**Market Street  
Marine Terminal  
Functional Replacement Project  
Portsmouth, NH**

# **NHDES Wetlands Permit Application Amendment & Request for More Information Response**

**NHDOT Project 15731  
Federal Project A000(909)  
NHDES File No. 2022-00429**

**RE: NHDES Request for More Information Response  
Standard Dredge and Fill Wetlands Permit Application (RSA 482-A)  
NHDES File Number: 2022-00429  
Subject Property: Market Street Marine Terminal, Portsmouth, Tax Map #119, Lot #5**

**S-104**  
SHEET 18 OF 18

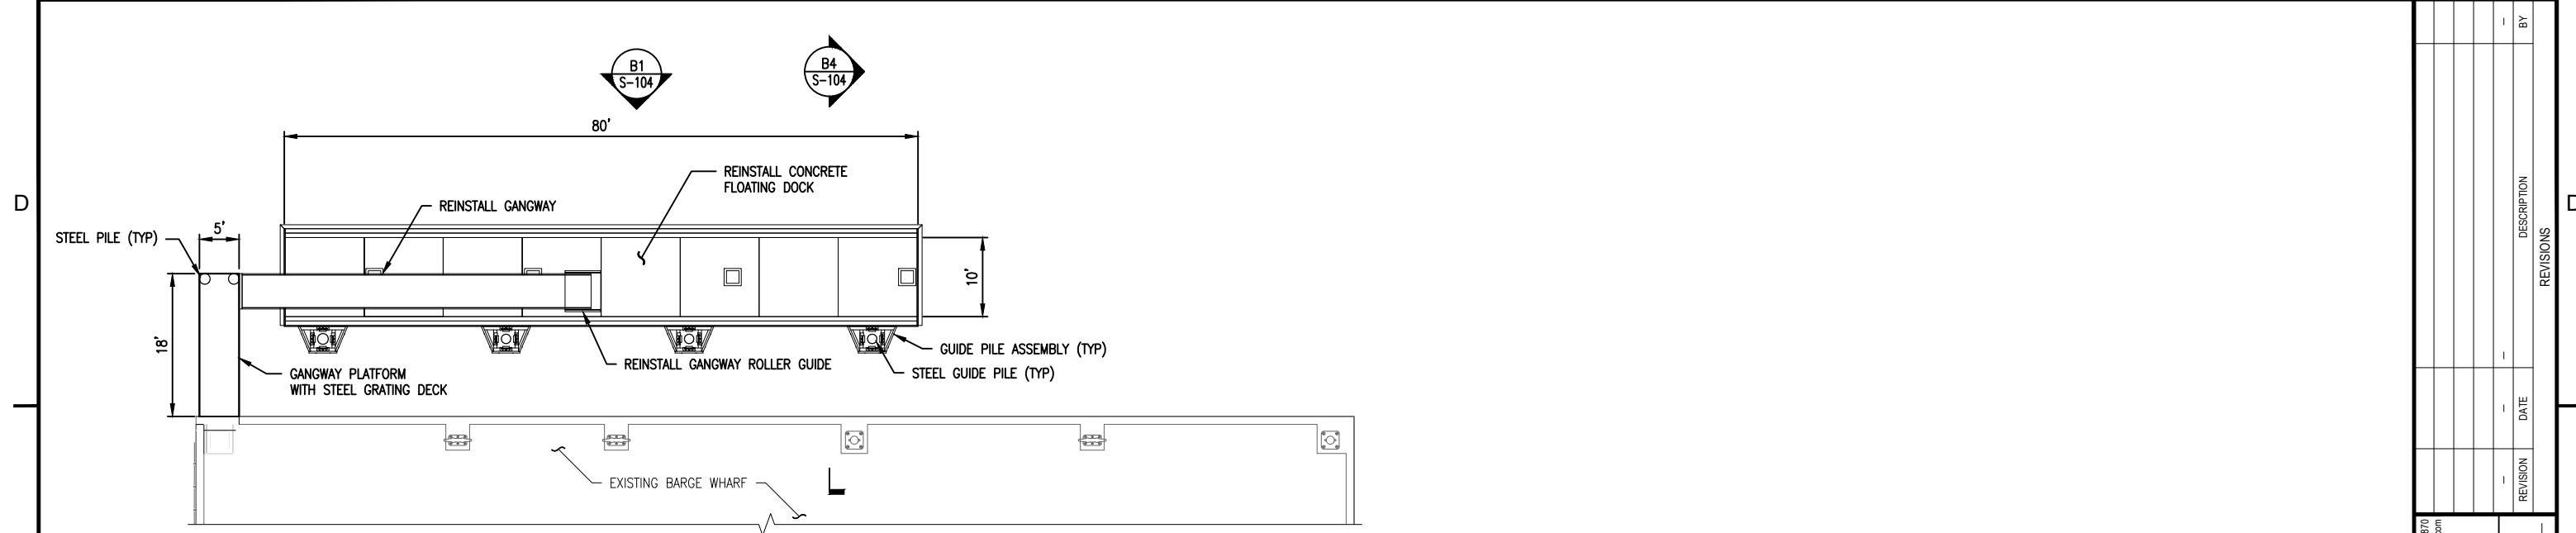
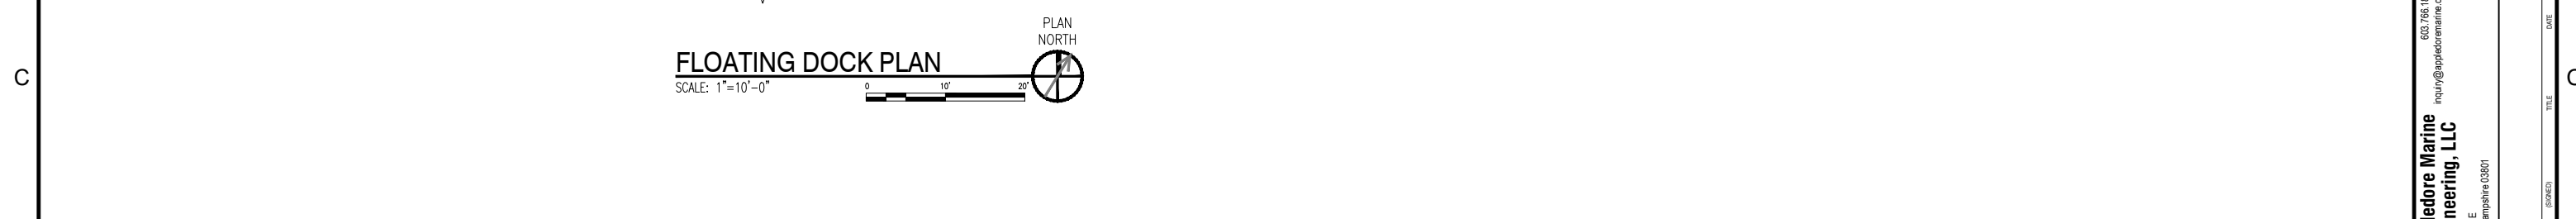
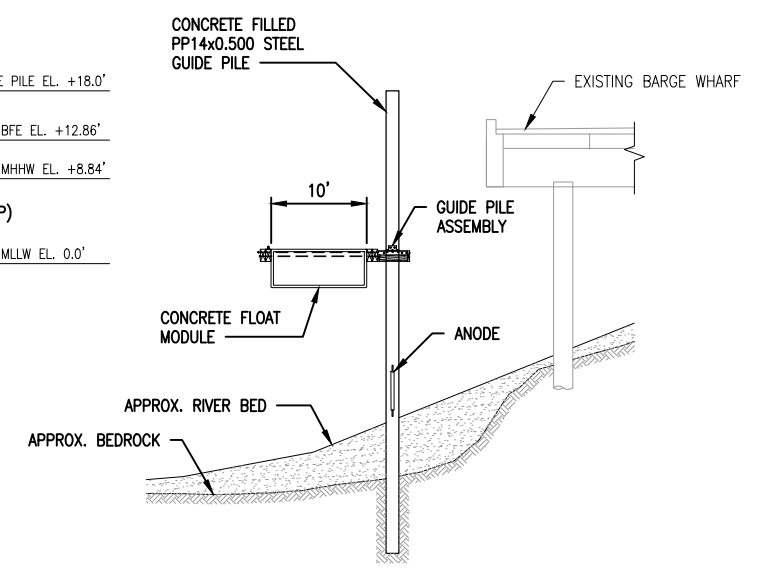
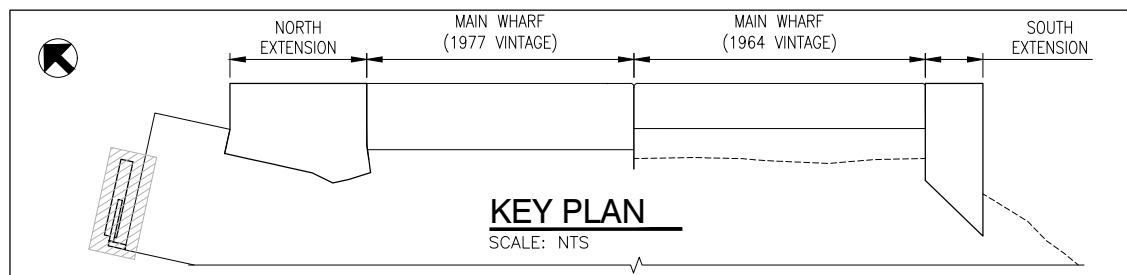
- 
12. Please submit revised plans that include construction details for the proposed floating dock that meets the design requirements in Env-Wt 606.03.

*Please refer to the attached revised Impact Plans (Sheet 18 of 18) for details of the proposed floating dock.*
